Application Number :3/2021/0556

Proposal: Application for reserved matters consent (appearance, scale, landscape and layout) pursuant to outline planning consent (ref: 3/2016/1082) for the demolition of 74 Higher Road and construction of up to 123 houses on land to the rear.

Location: 74 Higher Road Longridge PR33SY and land to the rear.

F3a: Plot proposal mitigation remarks

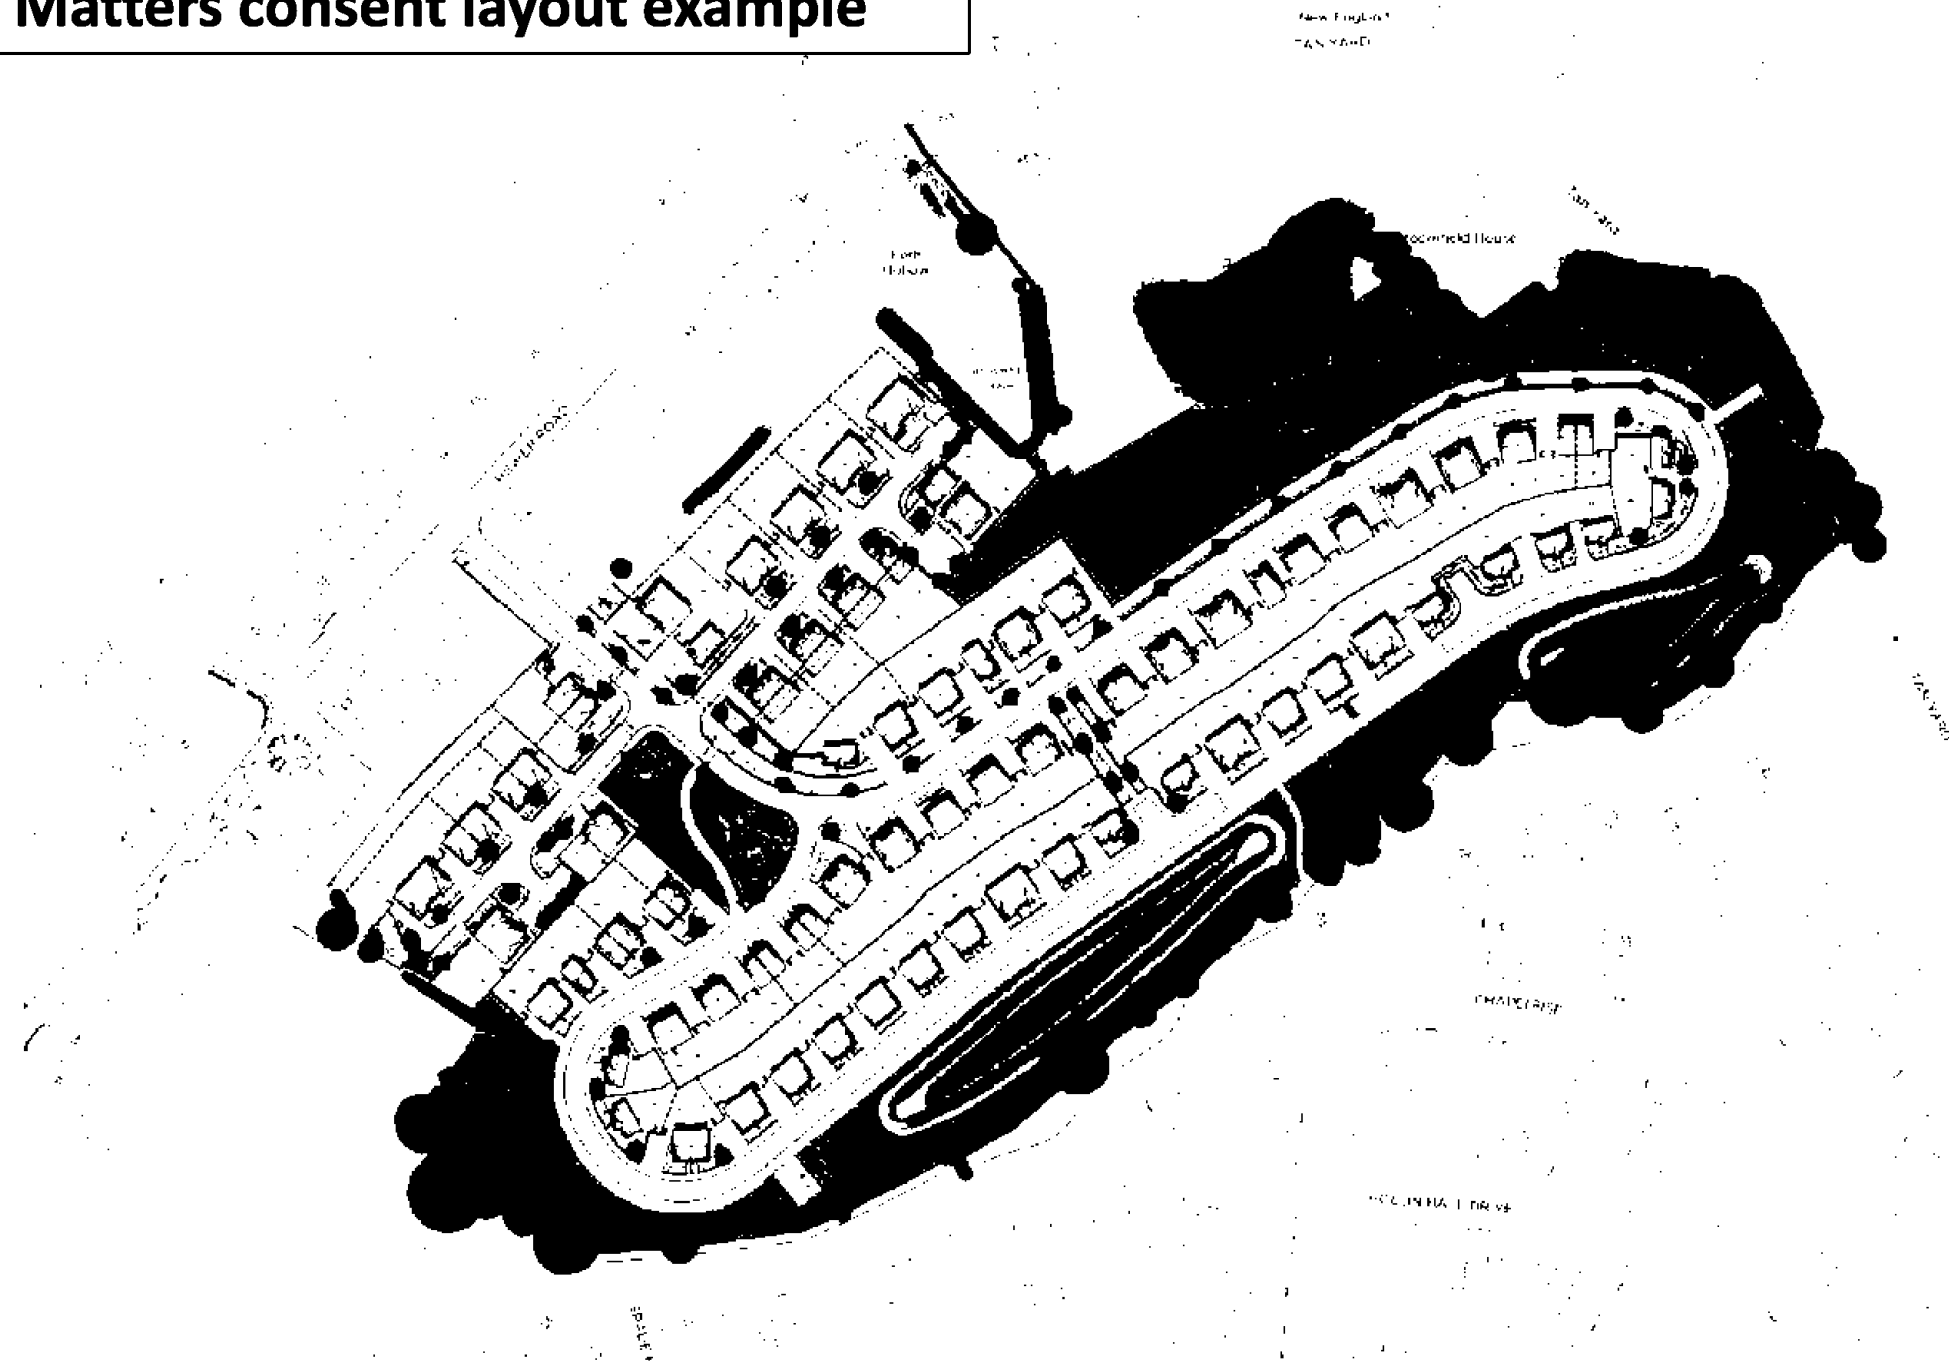
F3 With reference to the plan provided [reference F3a Plot proposal mitigation remarks]

Provided are three key views regarding current amenity and appearance, the approximate GL999 ground levels, given housing ridge heights and other supporting relevant details such as proposed retaining structure heights.

Ref F3a shows 54 Higher Road GL139m and the terraced garden to the rear and respective proposed levels for this site that we feel are unacceptable and would be to any other site proposal if it were considered on its own. The worst case is plot 115 114 that is [REDACTED] and would have a layout allowing the rear of two properties to back onto the side of garden at an elevated level with no clearly defined boundary treatment.

Plots 113 112 is unusually undefined in some information then identified as a house surrounded by bungalows, this double plot is also raised up to a GL139 along a natural topography some five meters lower.

We are showing an area of potential woodland enhancement and an environmental barrier/habitat corridor continuation along the south and east of 54 Higher Road with, say, a woodland pedestrian walking route to connect the independent silos of the site.

We are suggesting the refinement of the radius endpoint and introduction of a turning head to address the highways hierarchy and to enable the clockwise movement.

The layout appearance scale and landscaping at the boundary location to 54 Higher Road is unacceptable. We are suggesting a considered green barrier, with slight site layout refinement and reconsideration of ground levels, resulting in a saving of retaining structures and reduction in ridge heights afforded to those properties along the central area of the northern boundary as specified by the Planning Inspector.

F4a: Plot Adjustment proposal

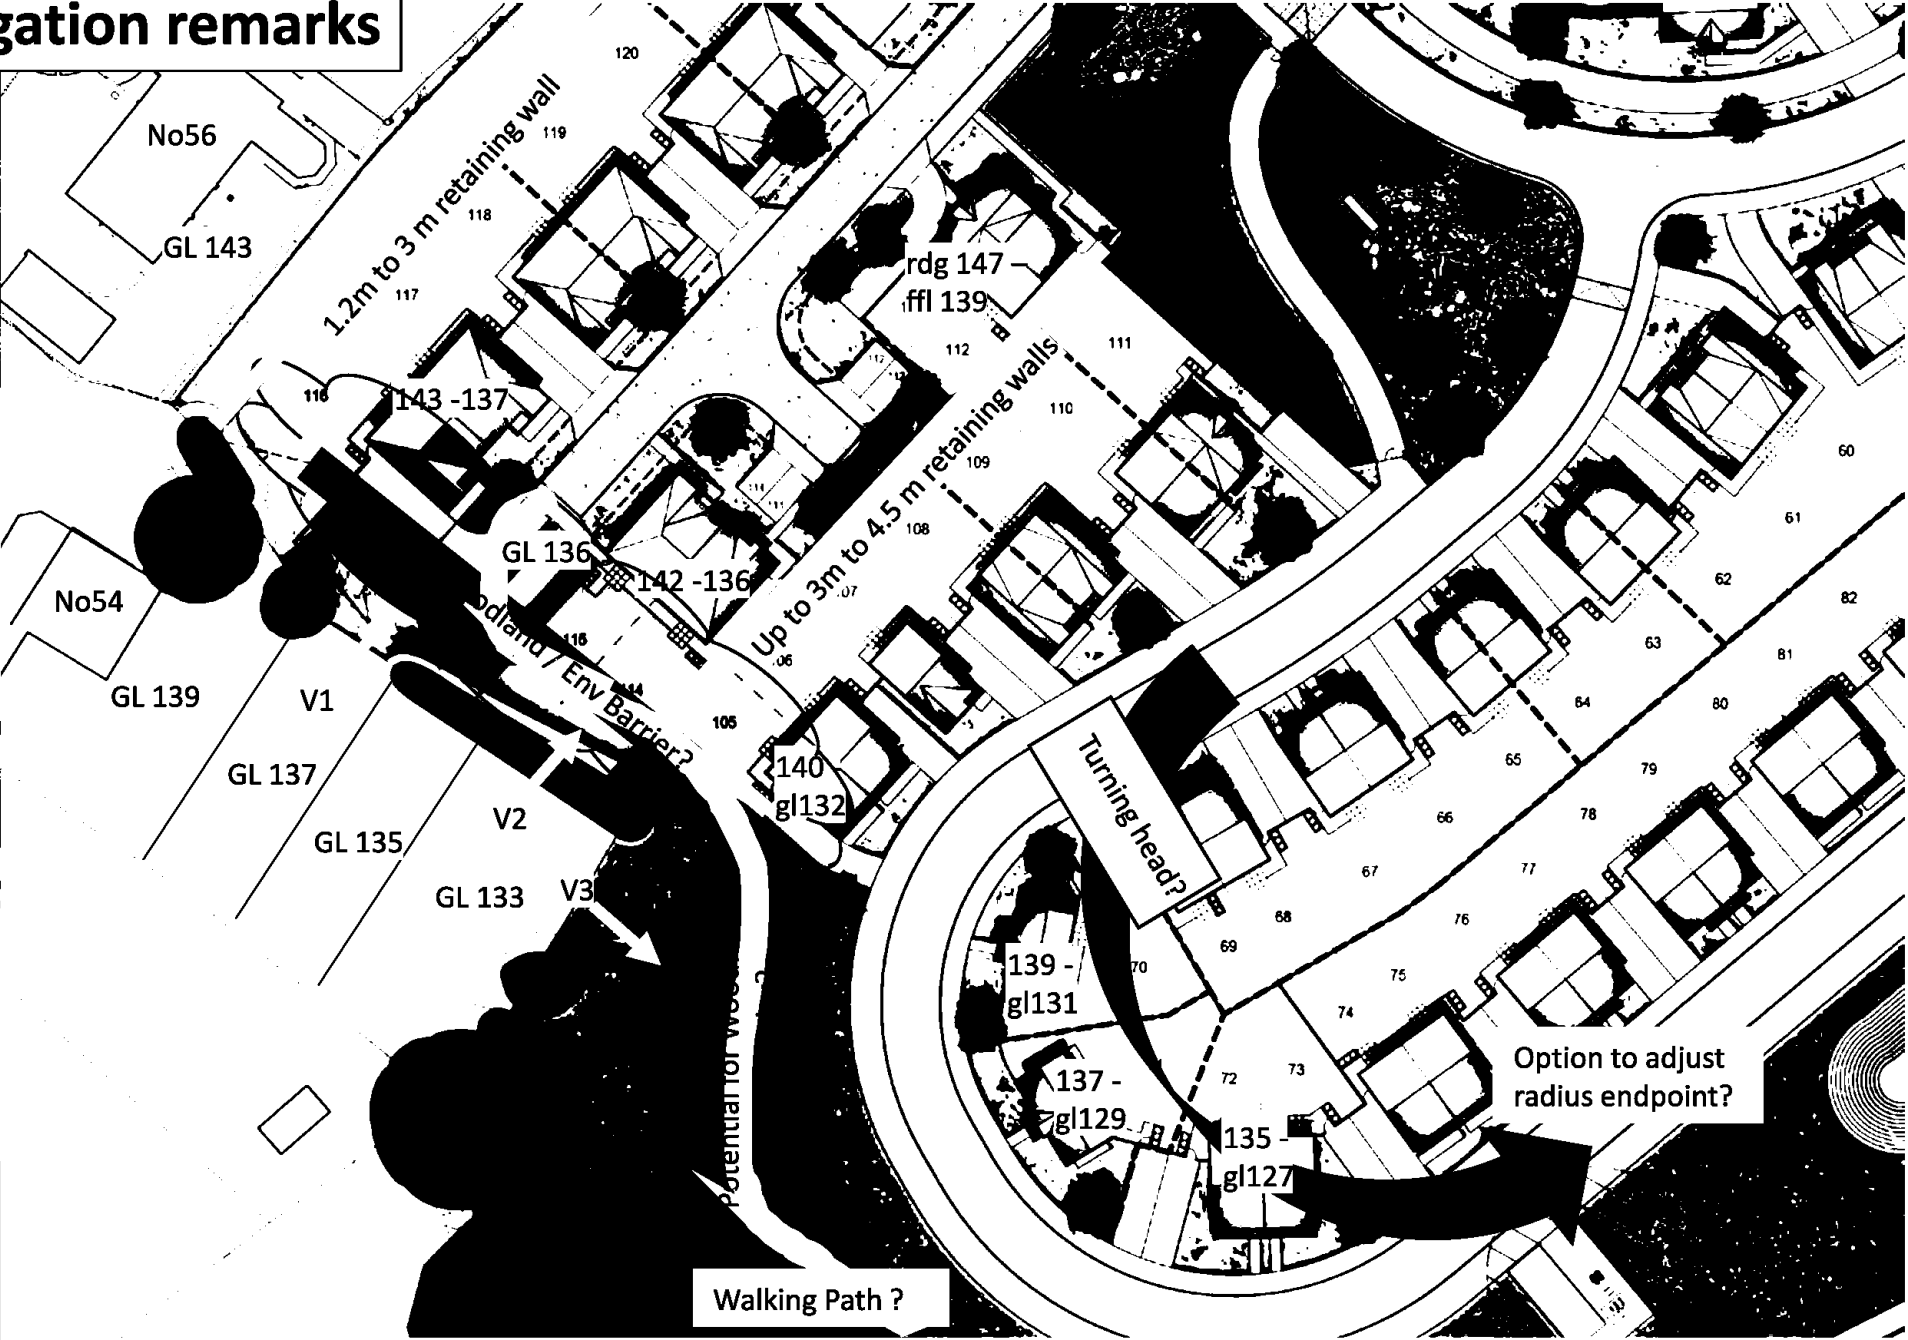
F4 With reference to the plan provided [reference F4a Plot Adjustment proposal]

Provided are our plot adjustment proposals to the layout in the northern boundary (west) interface with 54 Higher Road that addresses several concerns regarding the layout, appearance, scale and landscape proposals submitted.

By realising the obvious opportunity to naturally allocate displaced plots opposite No49 to No37 (a gain of up to at least 12 plots), the proposal within F4a modifies the existing plot categories and offers a relocation of plots to this potential windfall location and, in real terms, maintains the maximum number of plots developable on this site. [i.e. recategorizes four plots / relocates eight plots and refines six plots]

To explain the illustration : Relocate Plot 116 and Plot 117, refine the location of Plot 115 and Plot 114 opposite Plot 118 Plot 119, Recategorizes Plot 113 and Plot 114 from E/F to A/B, Relocate Plot 105 and Plot 106, Relocate Plots 74 Plot 75 Plot 68 Plot 69, refine location of Plot 70 Plot 71 Plot 72 Plot 73 further to the east, Recategorizes Plot 70 Plot 71 from H to A/B.
